ADDENDUM NO. Three (3)
PROJECT NO: 112741
TITLE OF PROJECT: Headquarters HQ Replacement Phase 1
FACILITY LOCATION: Tyler State Park, Smith County, Texas

ADDENDUM NO. 3

Tyler State Park
Headquarters
TPWD Project Number 112741
FPC Project Number 92705
October 8, 2020

1 MECHANICAL ENLARGED FLOOR PLAN - AREA A
SCALE: 1/4" = 1'-0"

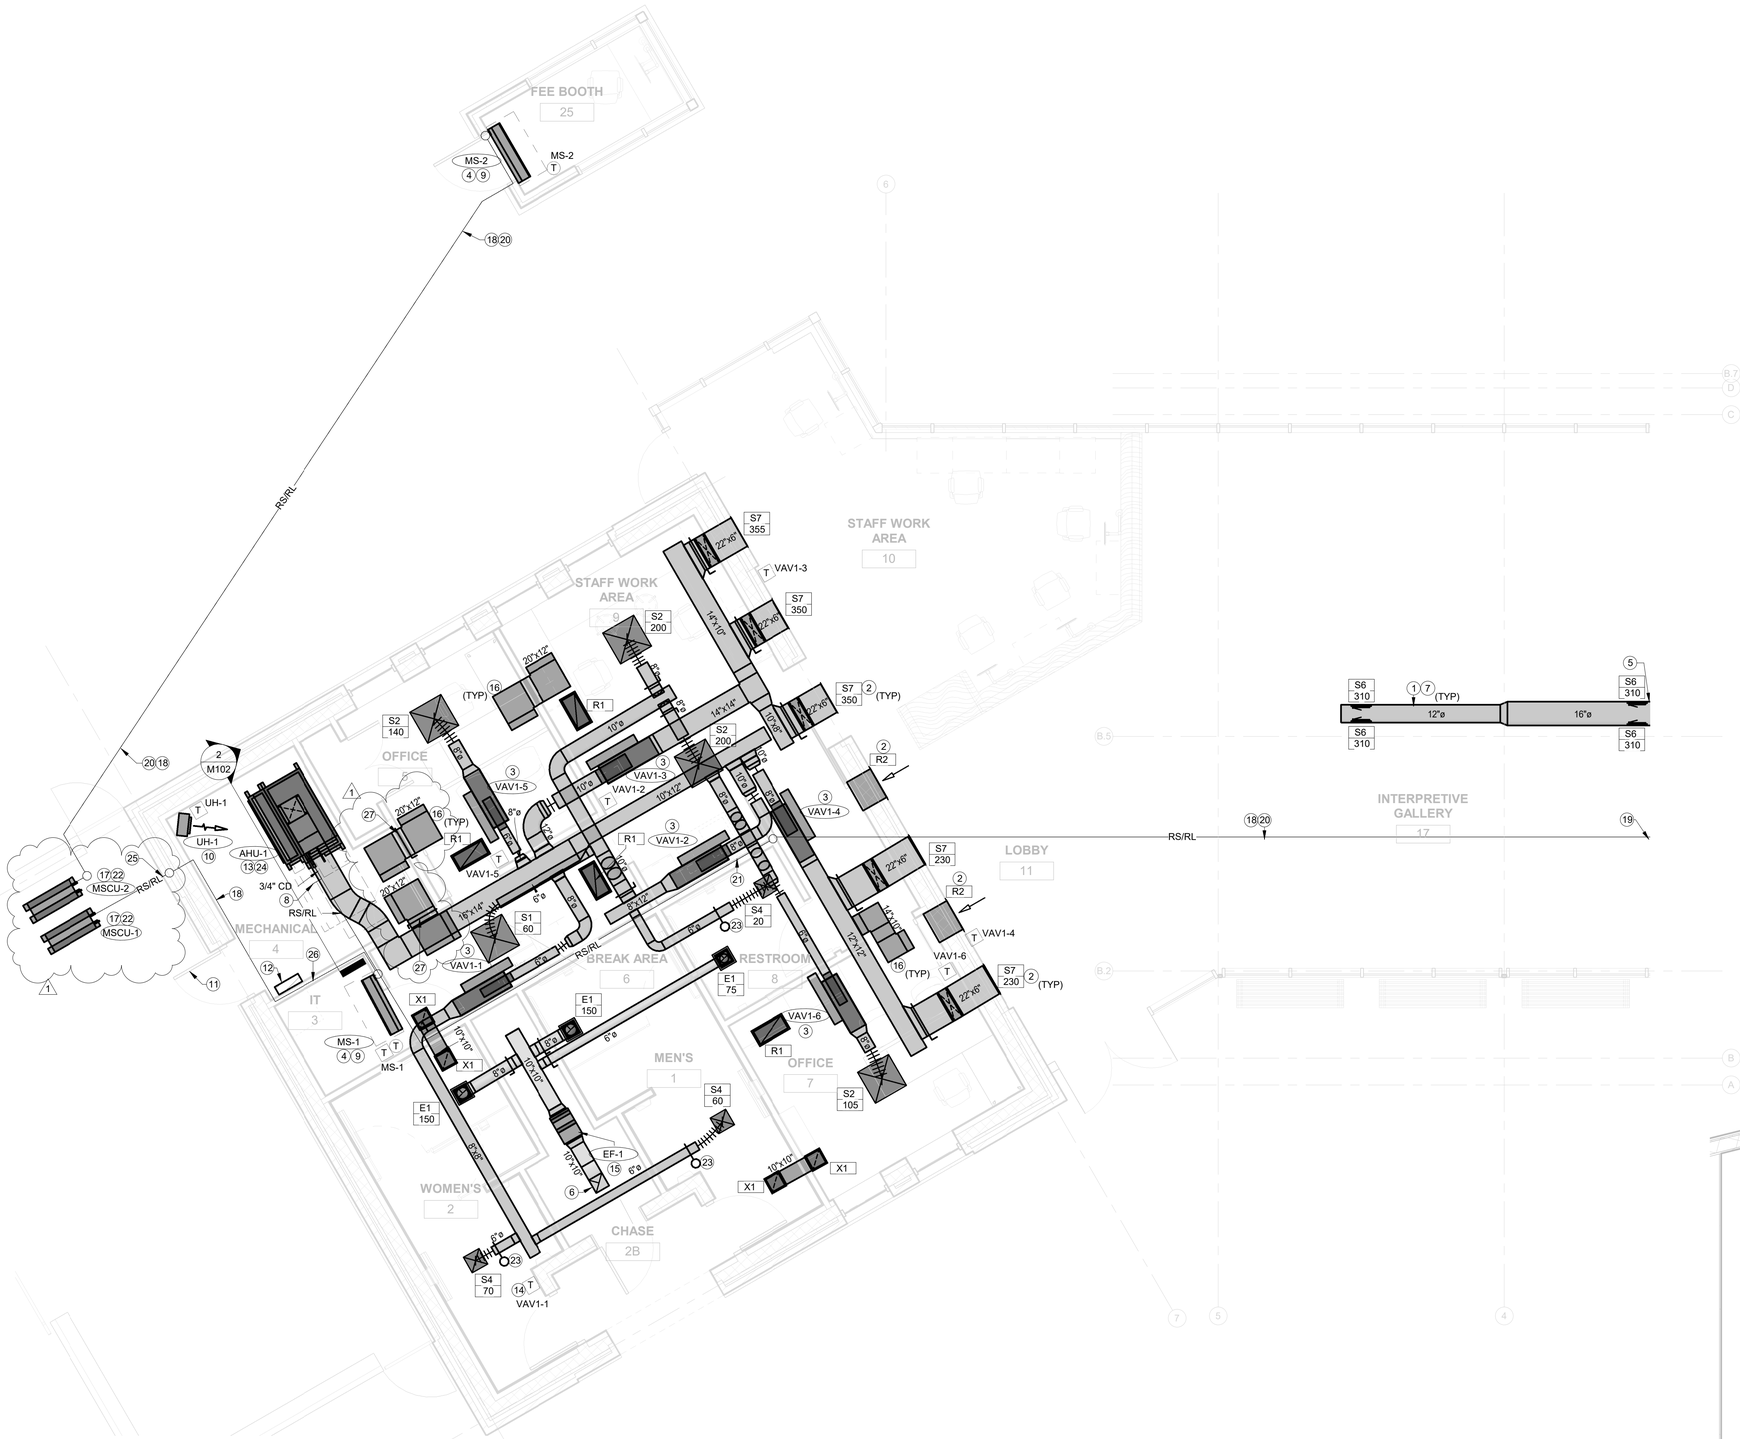
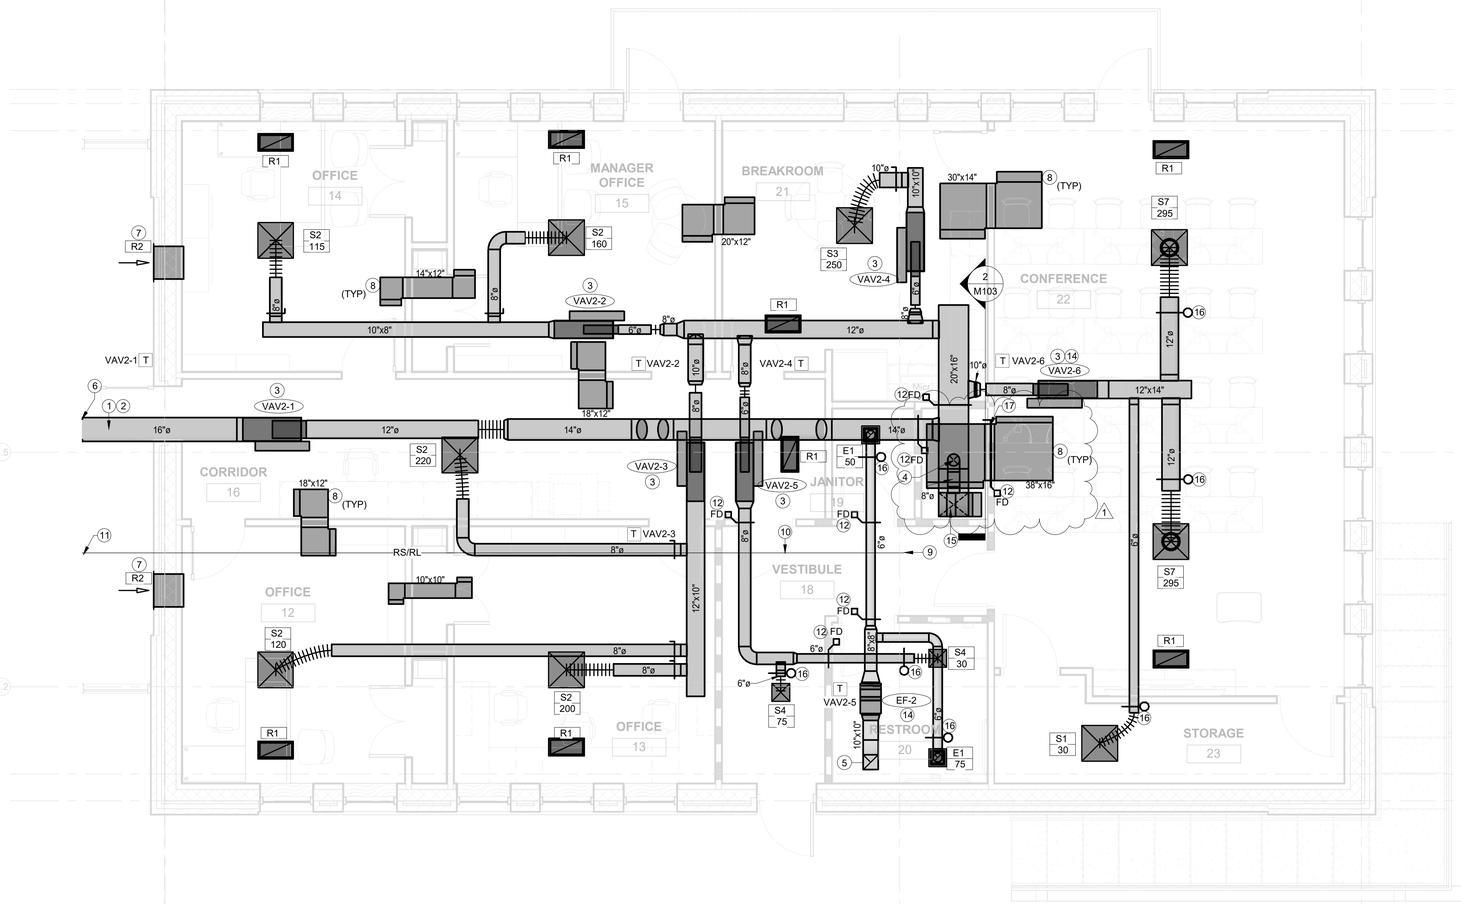
RE: Plan Sheet M103:
- Item 1: Revised rating of fire damper.
- Item 2: Revised keyed note #10.
- Item 3: Included manual dampers in return air transfers and added keyed note #17.

17. PROVIDE MANUAL DAMPER IN RETURN AIR TRANSFER FOR RETURN AIR BALANCING.

1 VAV DX SYSTEM CONTROL DIAGRAM

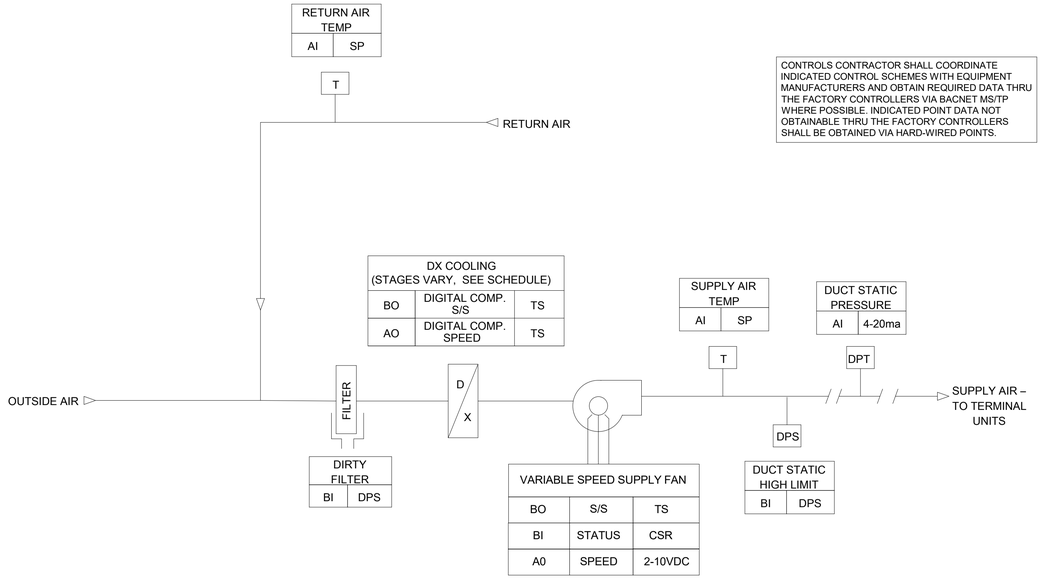
RE: Plan Sheet M402:
- Item 1: Revised controls diagram for Detail #1 (VAV DX System Control Diagram)

1 ELECTRICAL SITE PLAN

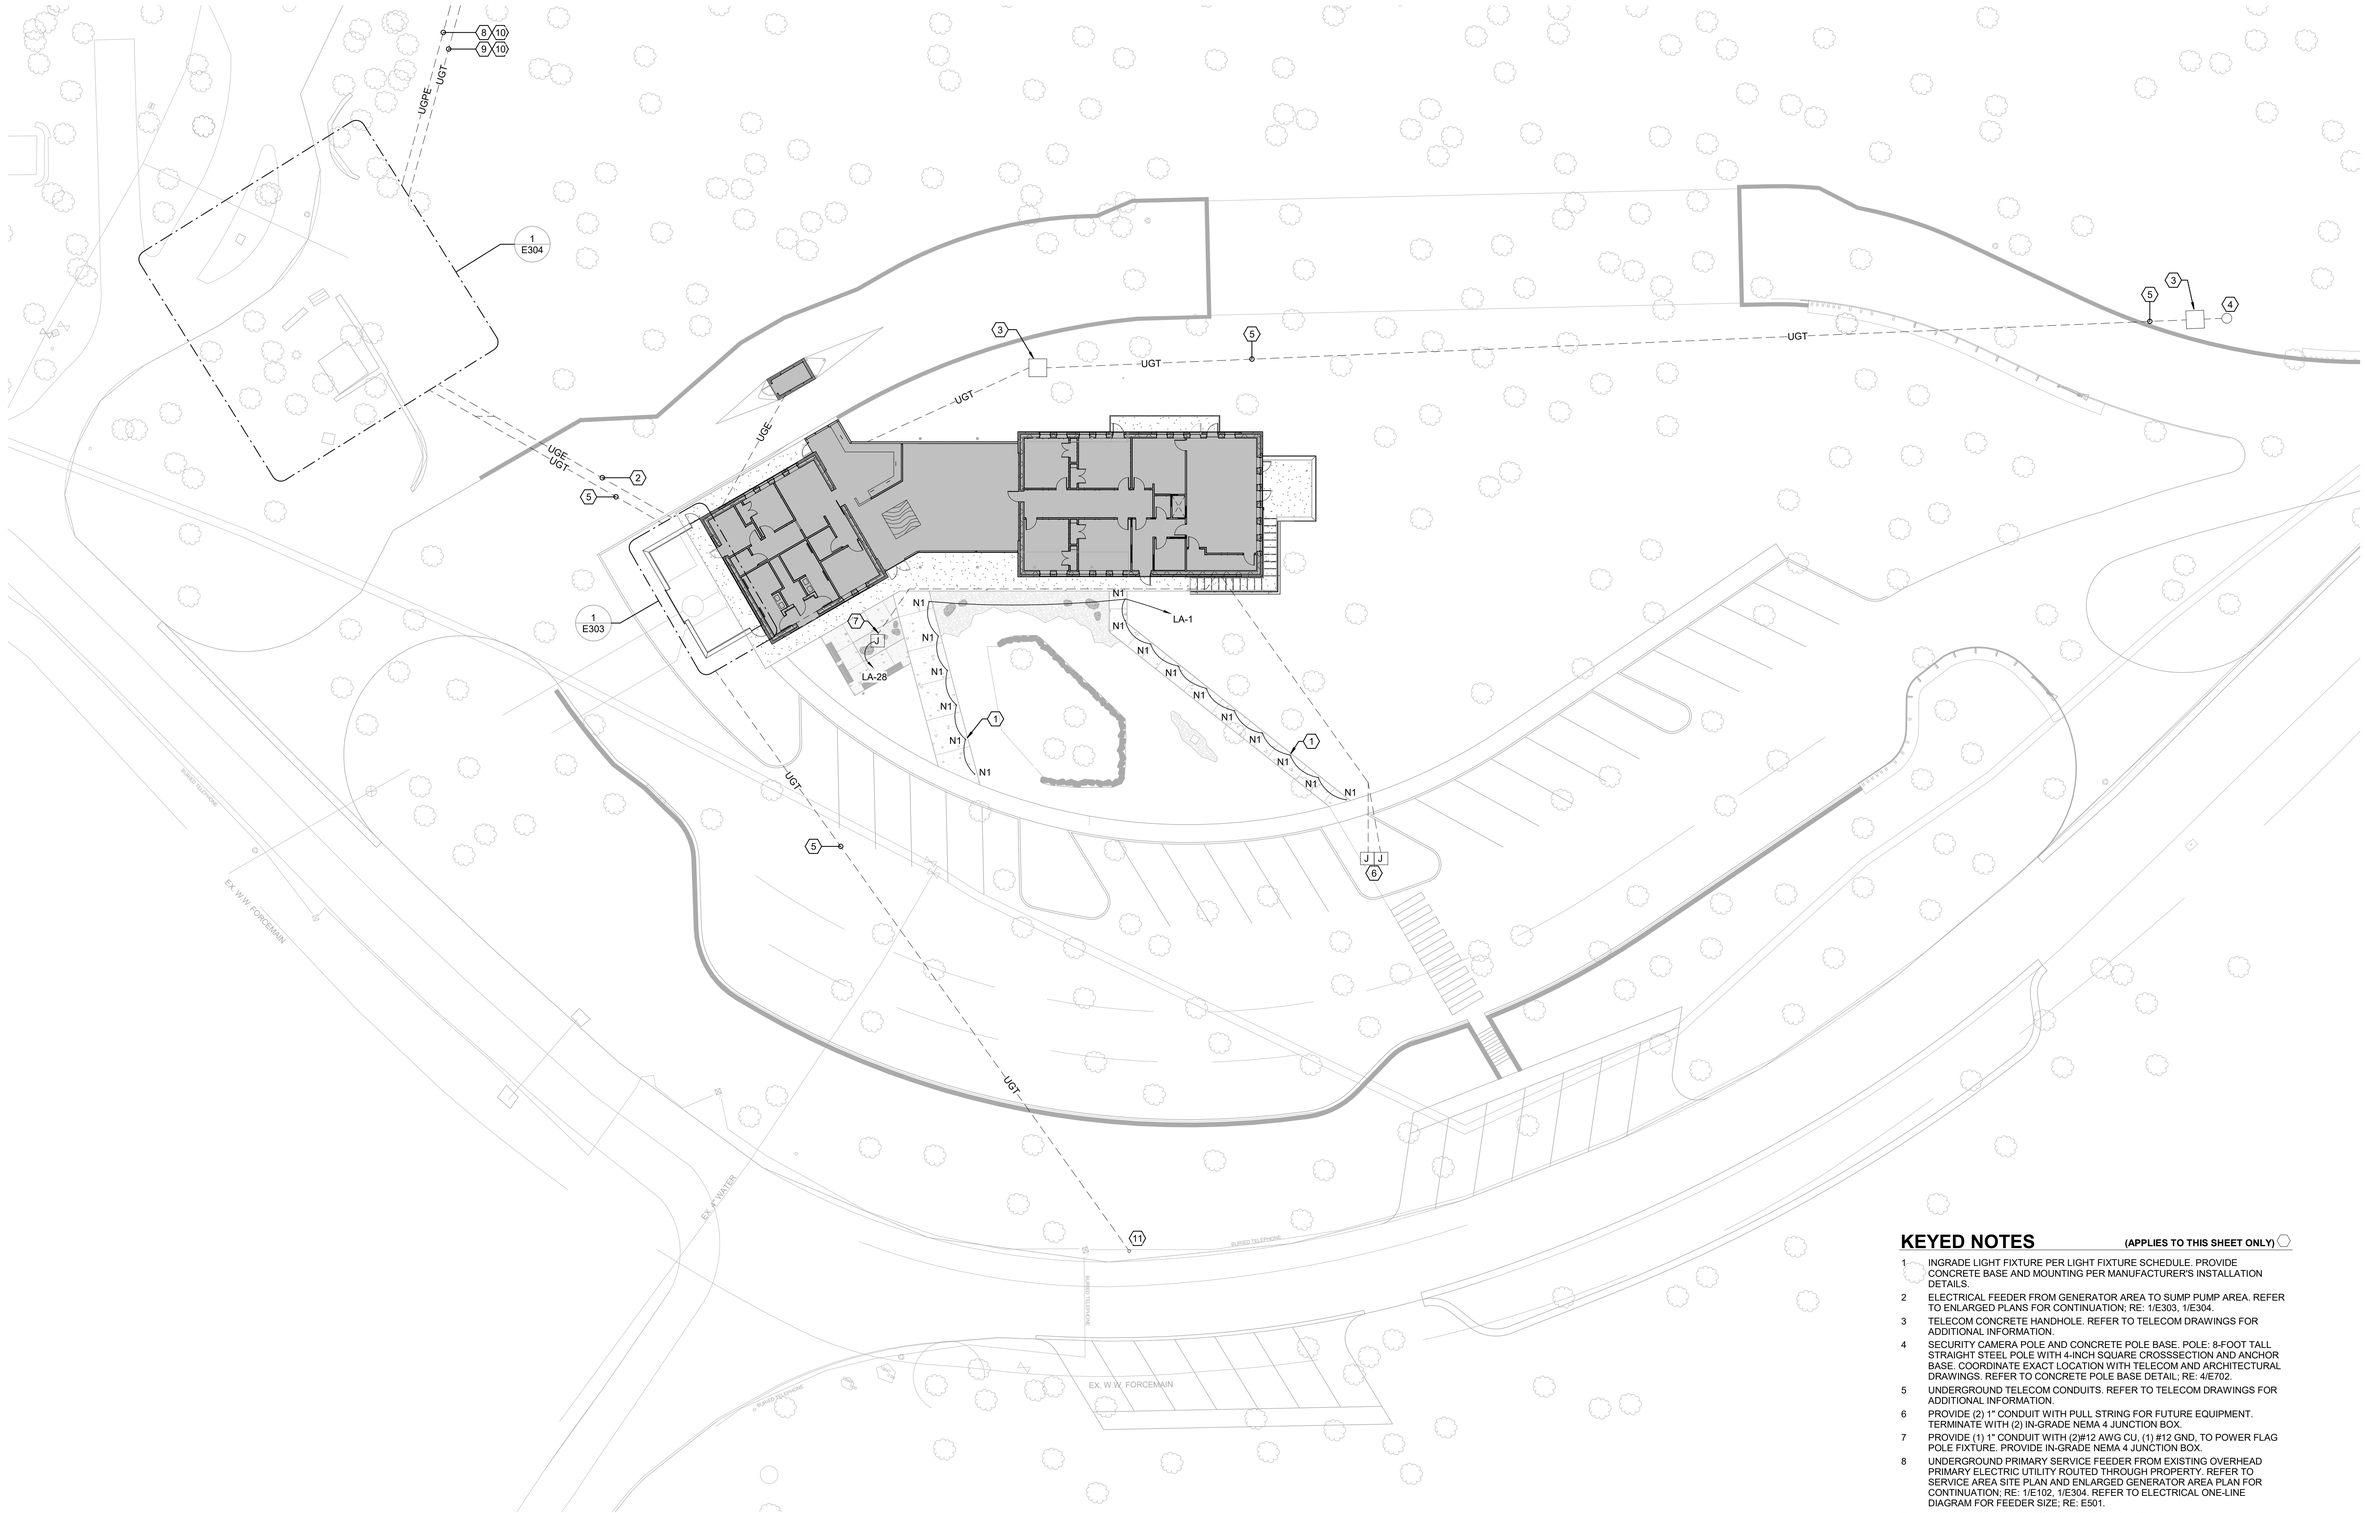
RE: Plan Sheet E101:
- Item 1: Revise keyed notes to clarify scope of work required for electrical service and communication ductbank installation.
